Drawing Review (surface level) Update

6th IG GTR9-PH2 Meeting
19-20/March/2013

Japan Automobile Standards Internationalization Center (JASIC)

Example from Drawing (133-5102)

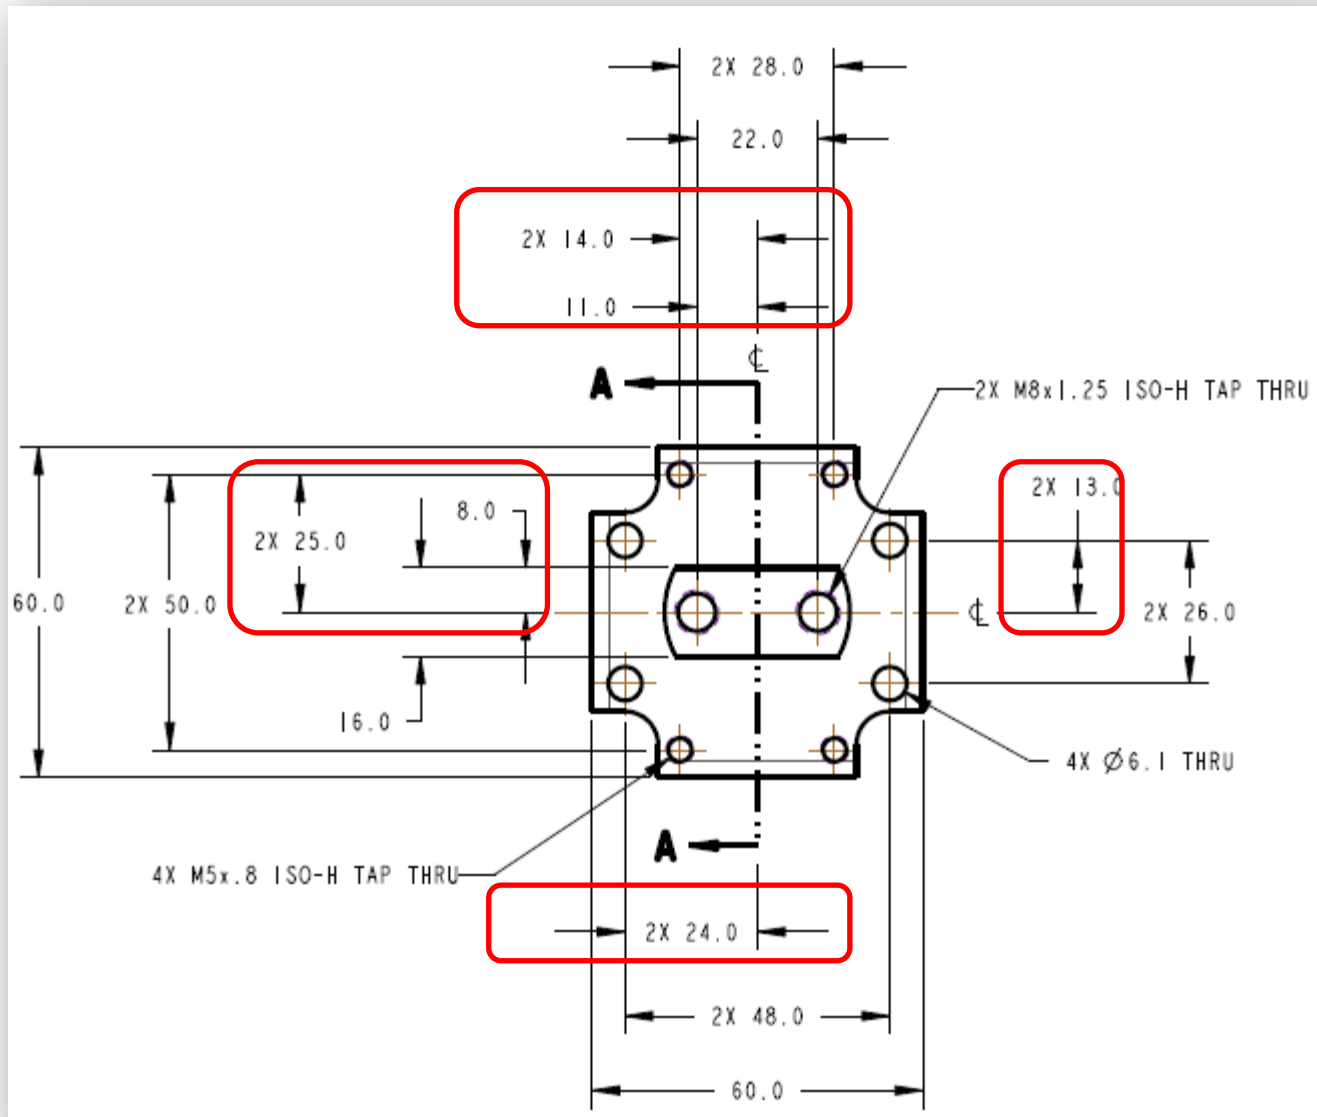
The dimensions in the red frames are unnecessary because the centerlines are shown

Example from Drawing (133-5001)

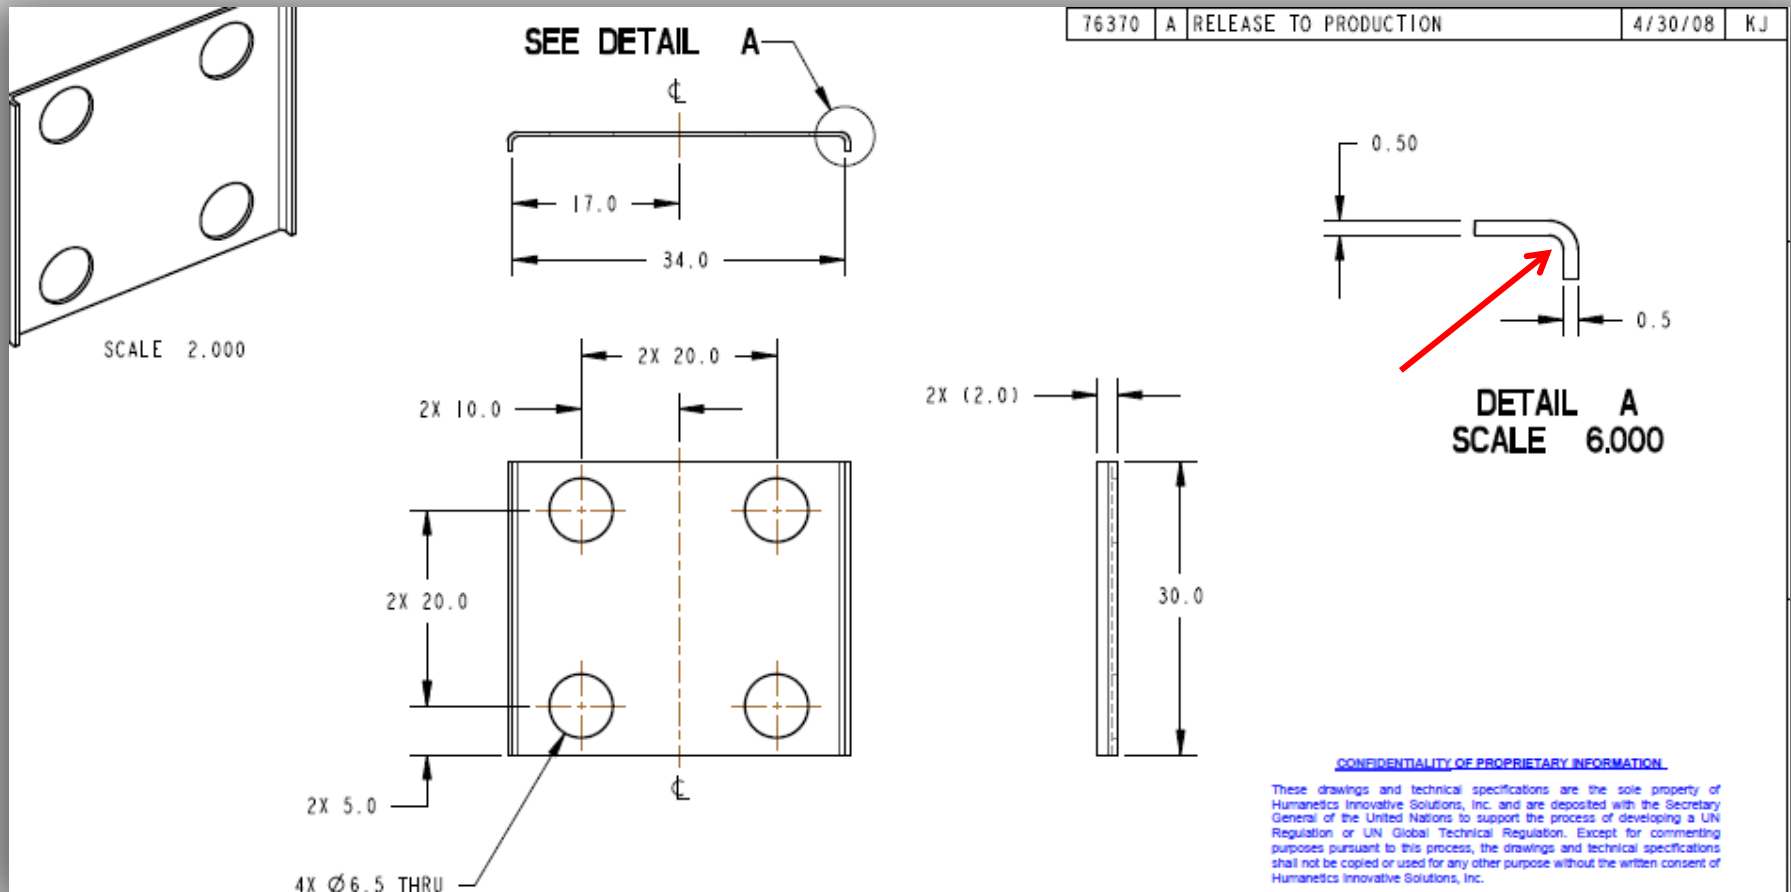
The radius shown in the red arrow is not specified in the drawing
